Louisville - Southern Indiana Ohio River Bridges Project
Kentucky Historic Preservation Advisory Team
Meeting – June 8, 2006
TARC Administration Building

Plan Review

I-65 Advance Construction Section Section 1 – Kennedy Interchange

Lighting Options

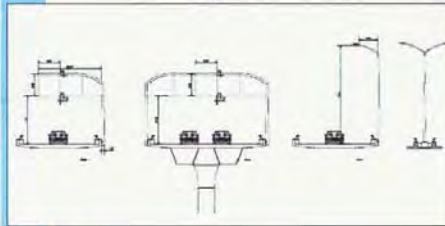
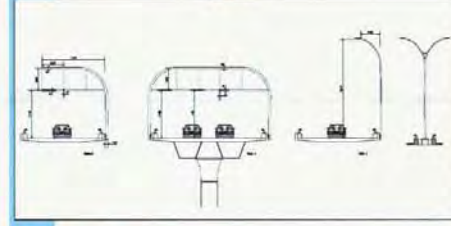
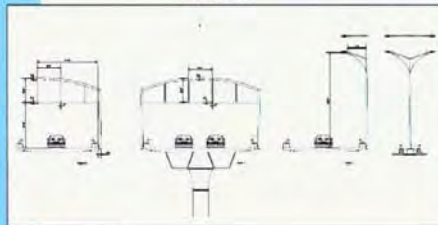
The appearance of the lighting and signing supports are important elements in the overall design of the project. What is your opinion of the proposed concepts? Do you have a preference?
